**To:** Mr. Rich LaBombard, Douglas City Manager  
**Date:** February 3, 2023  
**From:** Tricia Anderson, AICP  
**RE:** **Forest Gate Duplex Condominium Project**

RE: Forest Gate Condominium Development (#485 Ferry Street)  
Preliminary Engineering Review Comments – *REVISED SUBMITTAL*

# ARGENT MANAGEMENT GROUP, INC FOREST GATE CONDOMINIUMS

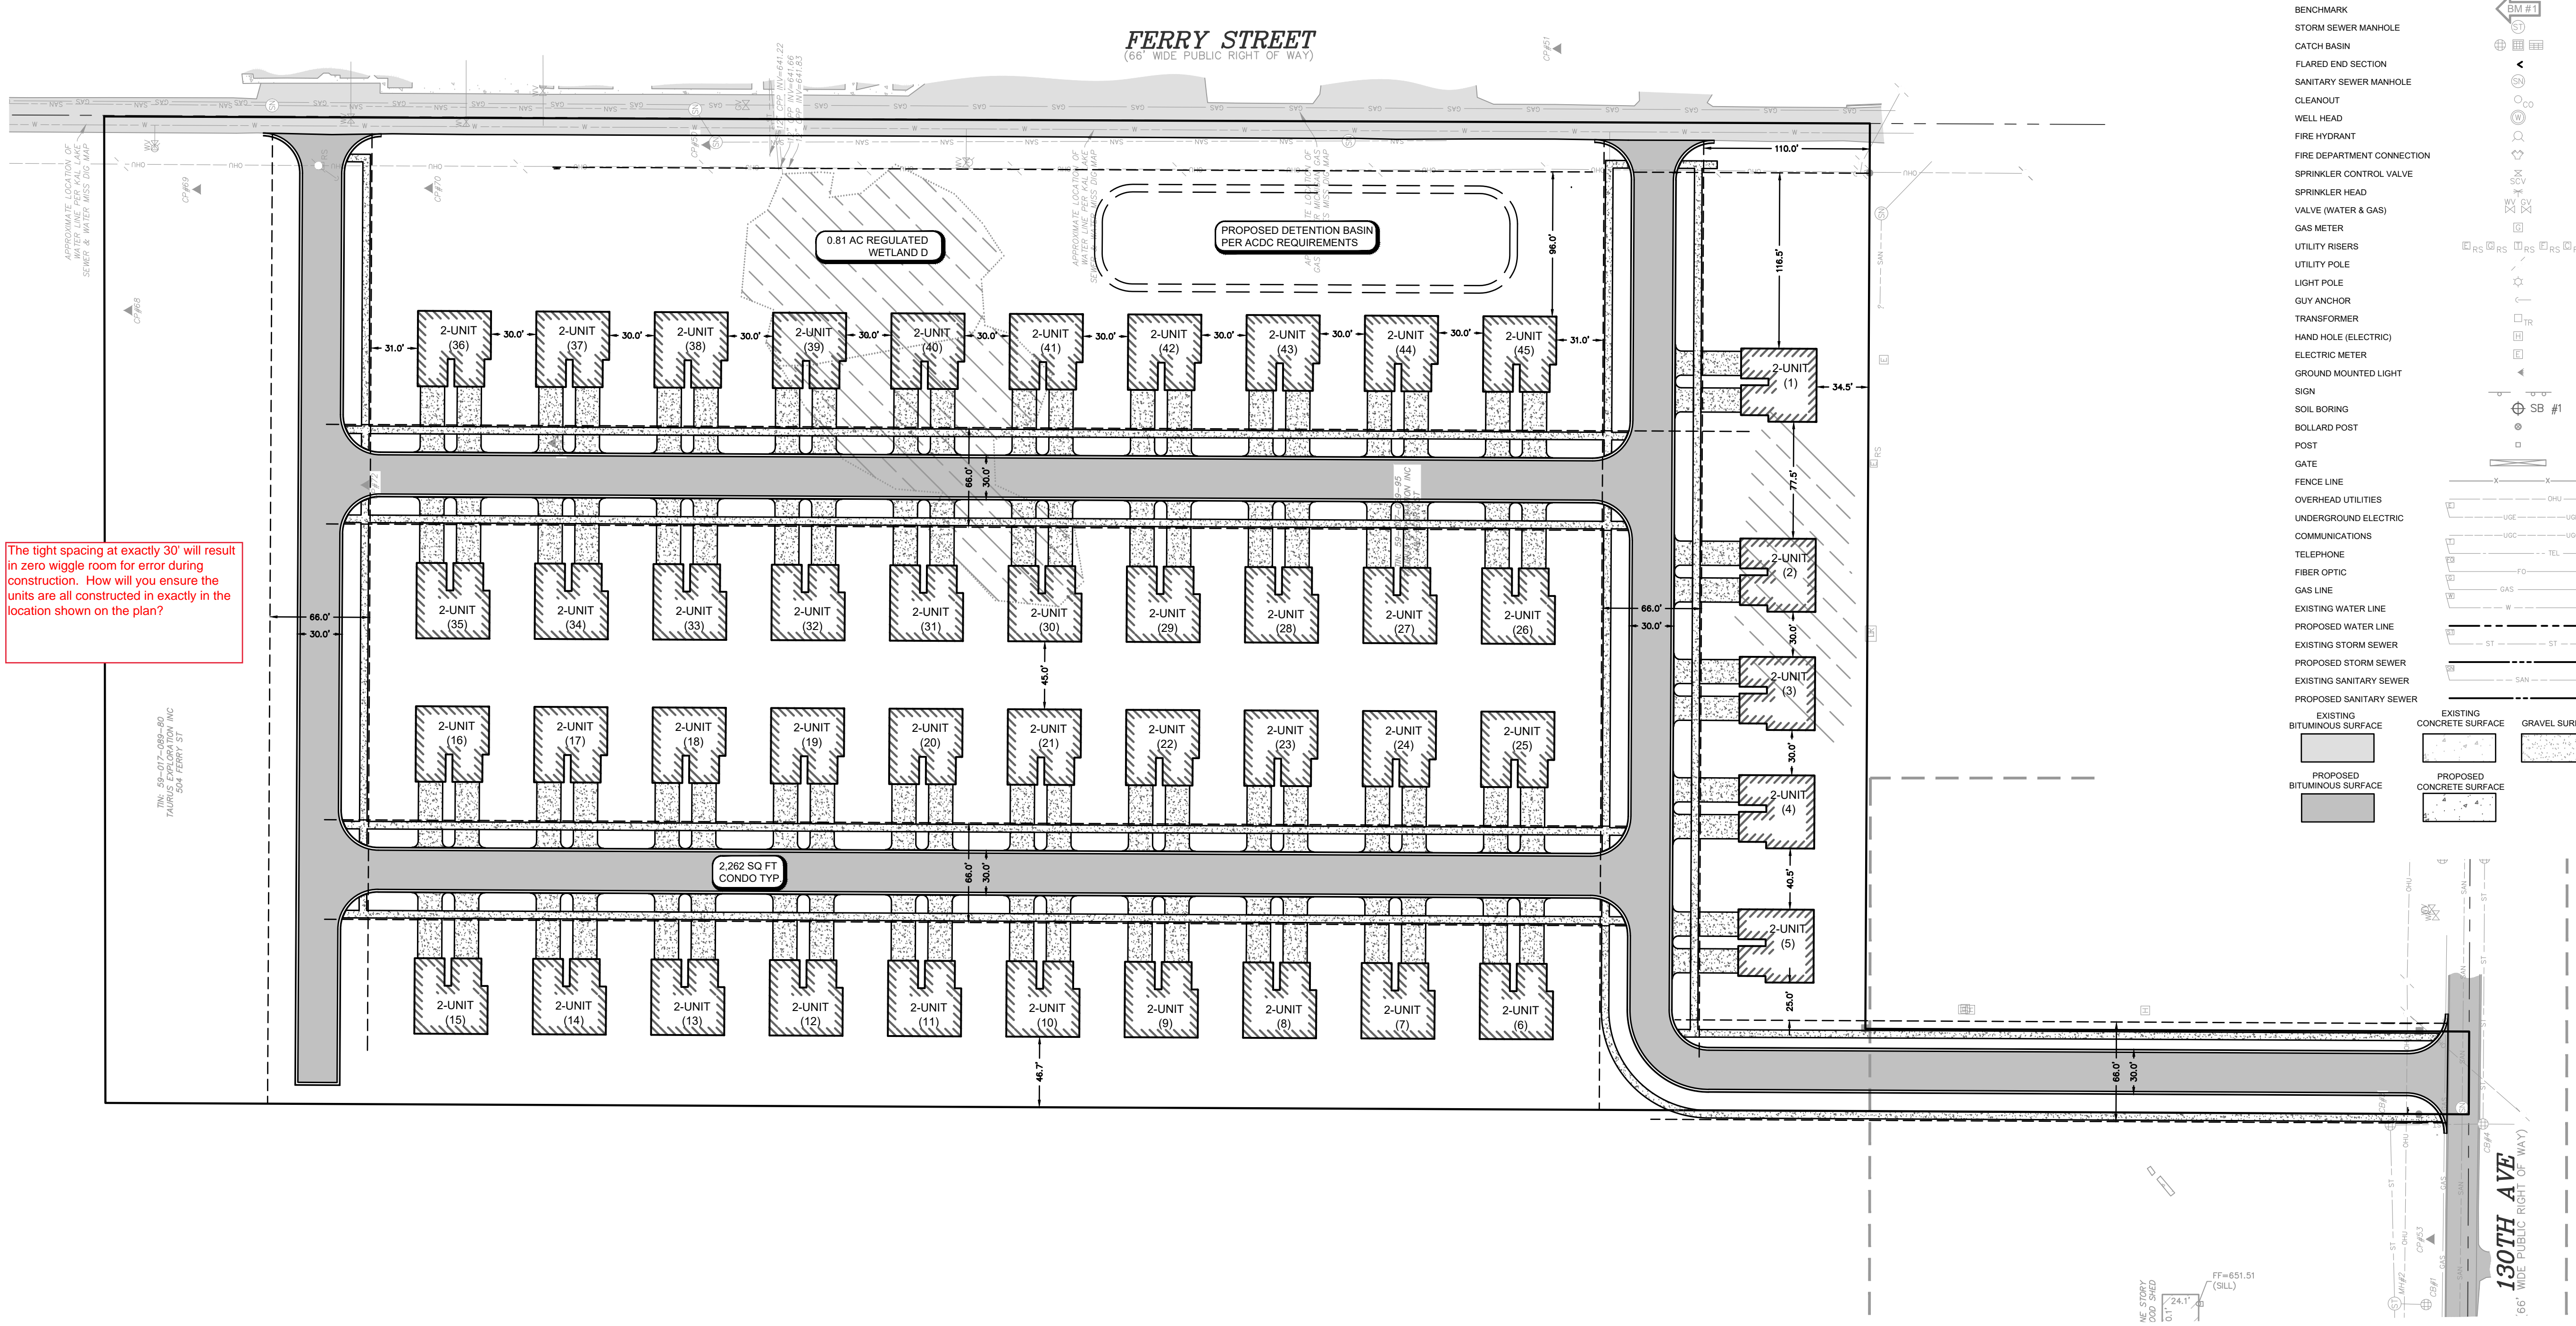
The light spacing at exactly 30' will result in zero wiggle room for error during construction. How will you ensure the units are all constructed in exactly in the location shown on the plan?

• EGLE PUBLIC WASTEWATER SYSTEM PERMIT  
• EGLE WETLAND PERMIT  
• **EGLE FLOODPLAIN PERMIT Is this property in a floodplain?**
- IMPACT ON PUBLIC SERVICES**  
PROJECT WILL NOT RESULT IN ADVERSE IMPACT TO PUBLIC SERVICES, INCLUDING POLICE & FIRE PROTECTION, UTILITIES, TRAFFIC OR ROADWAYS. **Include traffic study recommendations here.**

- PARKING**  
PARKING TO BE PROVIDED PER CITY STANDARDS. TWO PARKING SPACES WILL BE PROVIDED INSIDE EACH 416.5 SQ-FT GARAGE FOR RESIDENTS. TWO GUEST PARKING SPOTS ARE AVAILABLE IN THE DRIVEWAY TO EACH GARAGE. **for each dwelling unit.**

- SIGNAGE**  
SIGNAGE TO BE PROVIDED PER CITY STANDARDS
- STORM WATER MANAGEMENT**  
STORM WATER WILL BE COLLECTED IN A SERIES OF CATCH BASINS, PIPES, AND DITCHES AND ROUTED TO AN EXISTING LAKE ON THE EAST SIDE OF THE PROPERTY PER ALLEGAN COUNTY DRAIN COMMISSIONER REQUIREMENTS. **Existing lake? This section should indicate detention or retention and any structures associated with the pond that will need to be maintained.**

- WATER/SEWER SERVICE**  
SITE WILL BE SERVED BY NEW PRIVATE WATER AND SEWER SERVICES AND MAINS CONNECTED TO EXISTING MAINS ADJACENT TO THE SITE. **Each unit will be connected to the public system.**

- WETLANDS**  
THERE ARE WETLANDS ON THE SUBJECT PROPERTY. **We need the acreage here and what portion of that acreage will be impacted or filled.**
- FLOODPLAINS**  
THERE ARE NO REGULATORY FLOODPLAINS ON THE SUBJECT PROPERTY. PER FEMA FIRM MAP CN: 2605490001A. **agency permitting section says you will apply for a floodplain permit**

- LANDSCAPING**  
LANDSCAPING TO BE PROVIDED PER CITY STANDARDS. **You will need to add a separate landscaping page - it should be referenced here. The landscape page must show all the landscaping calcs in accordance with ord. plus show size and qty.**

- SITE LIGHTING**  
PROPOSED LIGHTING WILL CONSIST OF SHIELDED LIGHT POLES AND WALL PACKS. LIGHTING WILL BE CONSISTENT WITH OTHER USES IN THE AREA AND WILL COMPLY WITH ORDINANCE REQUIREMENTS. **where will you have wall packs? We need a photometric plan and lighting fixture specs. Proposed lighting must be shown on plan.**

- RESIDENTIAL UNITS WILL HAVE INDIVIDUAL WASTE BINS AND CURBSIDE WASTE COLLECTION.**
- CONSTRUCTION SCHEDULE**  
CONSTRUCTION IS ANTICIPATED TO START IN SPRING, 2023. **Please provide phasing for grading/earthwork, stormwater infrastructure, utilities, roads. Please also provide phasing schedule for buildings.**

- DRIVING SURFACES AND CLEARANCES**  
MINIMUM CLEAR HEIGHT OF 13'6" WILL BE MET PROVIDED OVERHEAD ELECTRICAL AT ENTRANCE FROM FERRY ST IS AT MINIMUM CLEARANCE. NO FURTHER OVERHEAD CONSTRUCTION IS TO OCCUR. ALL DRIVING SURFACES SHALL MEET THE 80,000 LB LOAD BEARING CAPACITY AND ALL ACCESS ROADS WILL BE COMPLETED PRIOR TO PHASED BUILDING CONSTRUCTION. ROAD GRADES SHALL NOT EXCEED 10% SLOPE AT ANY GIVEN INTERVAL. ON STREET PARKING WILL BE ON THE NORTH AND SOUTH ROADS ON THE OPPOSITE SIDE OF THE DRIVEWAYS. NO PARKING WILL BE PERMITTED ON ROADS THAT TRAVEL NORTH TO SOUTH. THIS IS DUE TO EMERGENCY ACCESS AND ALLOWING PLOWING OF SNOW AND ICE. **Is this still accurate? OWNER SHALL PROVIDE SNOW AND ICE REMOVAL UNTIL THE CITY TAKES OVER TO MAINTAIN ALL WEATHER DRIVING CAPABILITIES. Not sure this statement is necessary.**

**OVERALL PLAN**

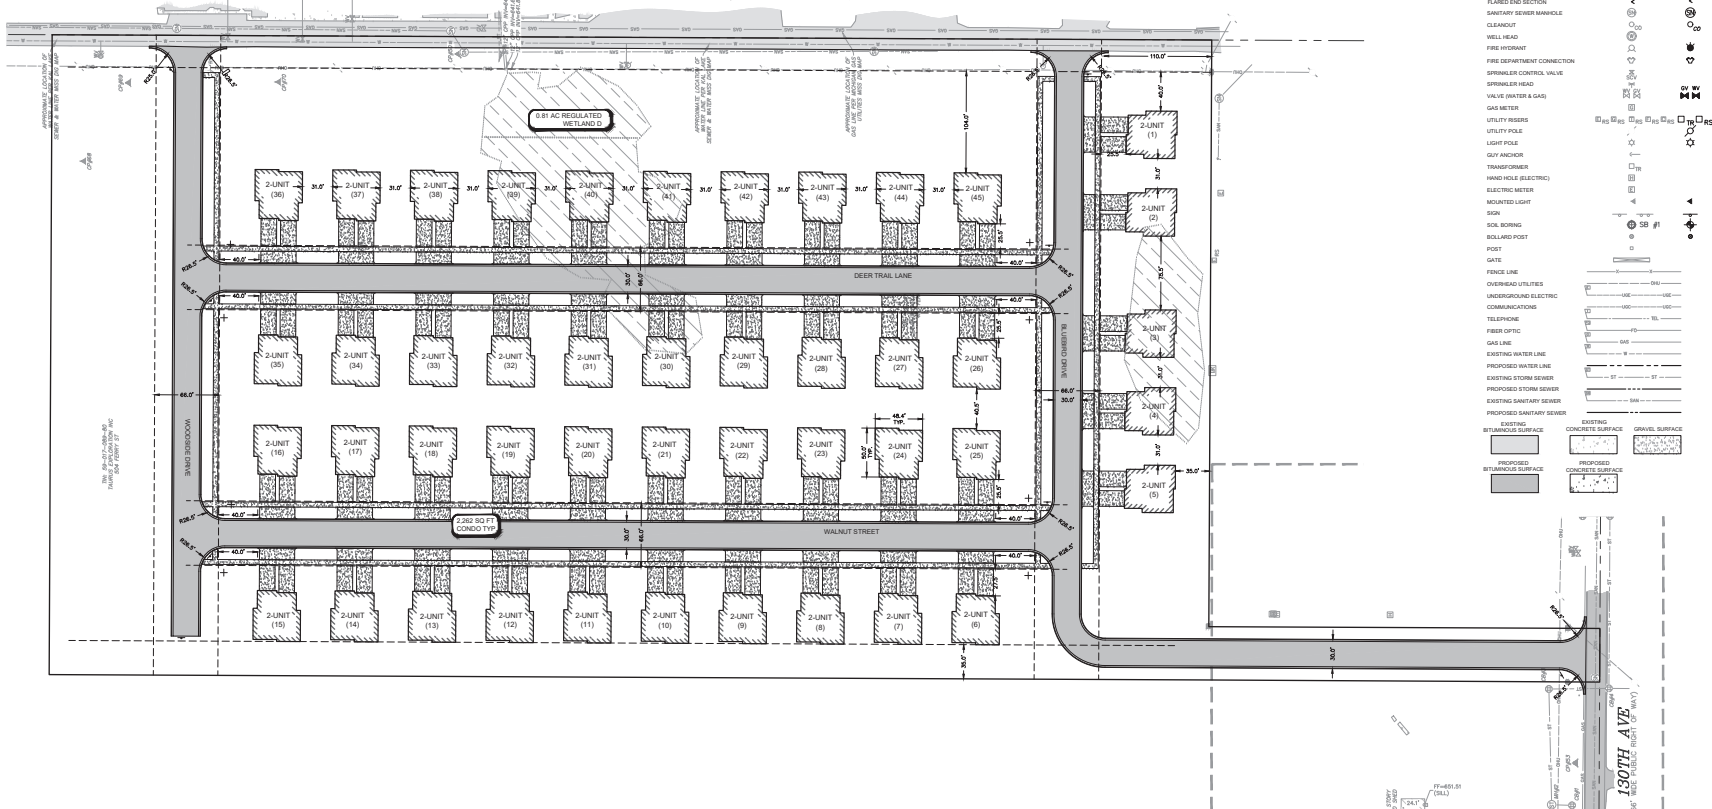
2. The survey map included in the drawings seems to be from a previous development plan. This should be revised to show the current project and parcels involved. Survey dimensions need to be provided on the overall plan (C-100) for this development.
